APPLICATION NO.	FILING DATE	FIRST NAMED INVENTOR	ATTORNEY DOCKET NO.	CONFIRMATION NO.
10/506,626	09/03/2004	Yuichi Terada	DK-US020720	5169
22919 7590 03/24/2009 GLOBAL IP COUNSELORS, LLP 1233 20TH STREET, NW, SUITE 700 WASHINGTON, DC 20036-2680				
EXAMINER				
RAHIM, AZIM				
ART UNIT		PAPER NUMBER		
3744				
MAIL DATE		DELIVERY MODE		
03/24/2009		PAPER

Office Action Summary

DETAILED ACTION

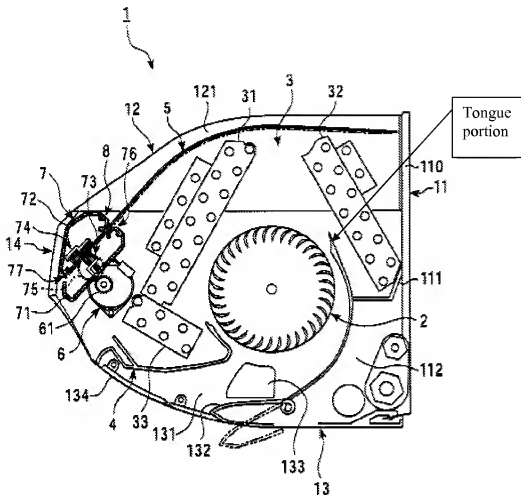
Takashima et al. teach a wall mounted indoor air conditioning unit (see figure 1) that includes a base panel (110) mounted to a wall (11), wherein the air conditioning unit includes a support unit (111) for the heat exchanger (illustrated in figure 1) and a tongue portion (annotated below), wherein the support unit and tongue portion does not extend to the apex of a fan (2) (illustrated in figure 1) enabling viewing of the apex of the fan from the rear absent the base panel (illustrated in figure 1).

It would have been obvious to one having ordinary skill in the art at the time the invention was made to have modified the air conditioning unit of Gungi et al. to place its tongue portion below the apex of the ventilation fan as taught by Takashima et al. in order to collect condensation and to enable maximum heat exchange to heat exchanger 520 by enabling more air blown by the ventilation fan to contact the heat exchanger, thus improving cooling efficiency.
